**YOUR REF:** PDR 15510  
**OUR REF:** OP 3546/2009 (766701)

**DECISION NOTICE FOR OPERATIONAL WORKS  
STAGES 4B & 4C OCEAN BREEZE ESTATE  
905L COOYA BEACH ROAD, BONNIE DOON**

**DECISION NOTICE FOR OPERATIONAL WORKS  
STAGE 4B & 4C OCEAN BREEZE ESTATE  
905L COOYA BEACH ROAD, BONNIE DOON**

Drawing Title	Drawn: NP	Designed: GCH	Verified: AM/P																																																														
COOYA BEACH ROAD CROSS SECTIONS SHEET 1 OF 2	Approved: +	Date: JAN 2016	Revision: B

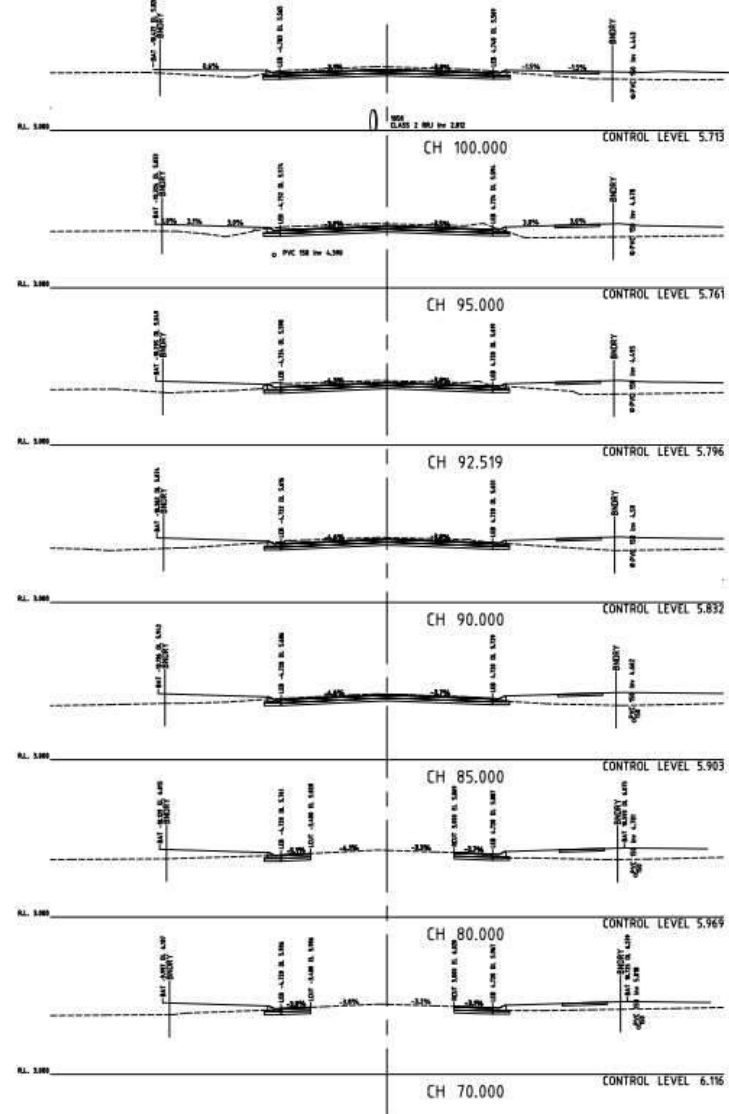
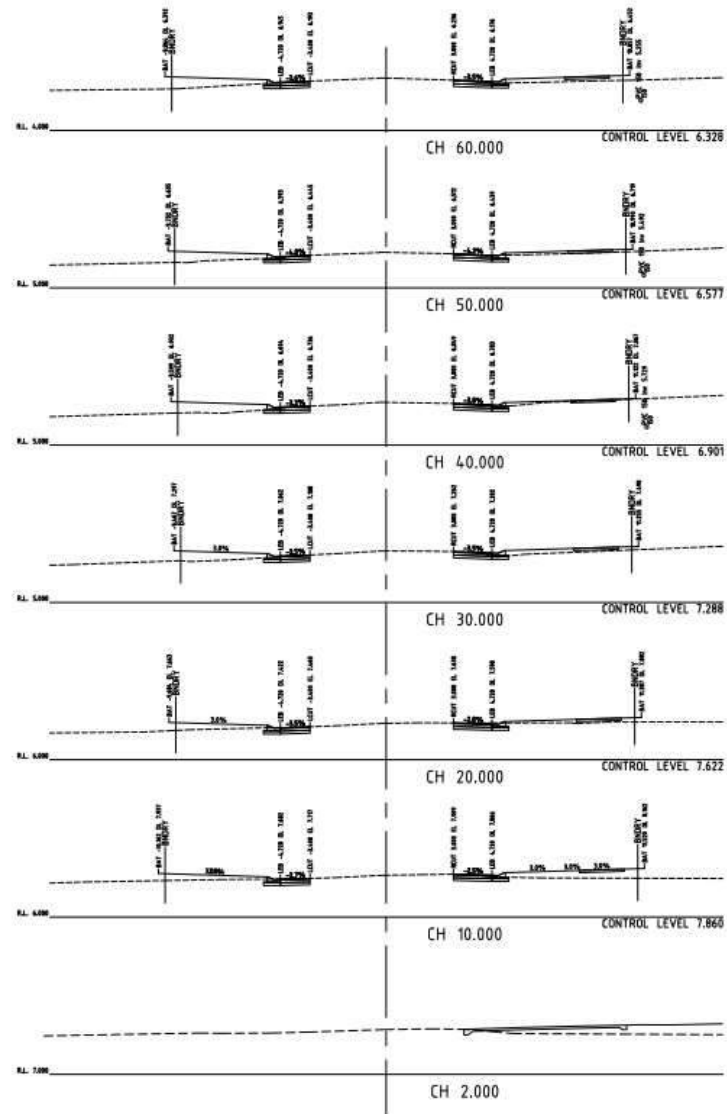
- b. Provide amended design drawings for Cooya Beach Road with the low point in the road lowered a further 150mm from that shown on PDR drawing 15510-C07 revision B.

The revised road level is required to limit ponding in Julaji Close to within the QUDM depth limits and to provide reduced risk of flooding to the new lots upstream from Cooya Beach Road in the event of pipe and/or inlet blockages.

The vertical curve radii and road cross fall are to be generally as per the current design but the overall road level at the low point is to be lowered. The new extent of upgrade works is to be documented on revised plans approved by Council prior to the pre-start meeting.
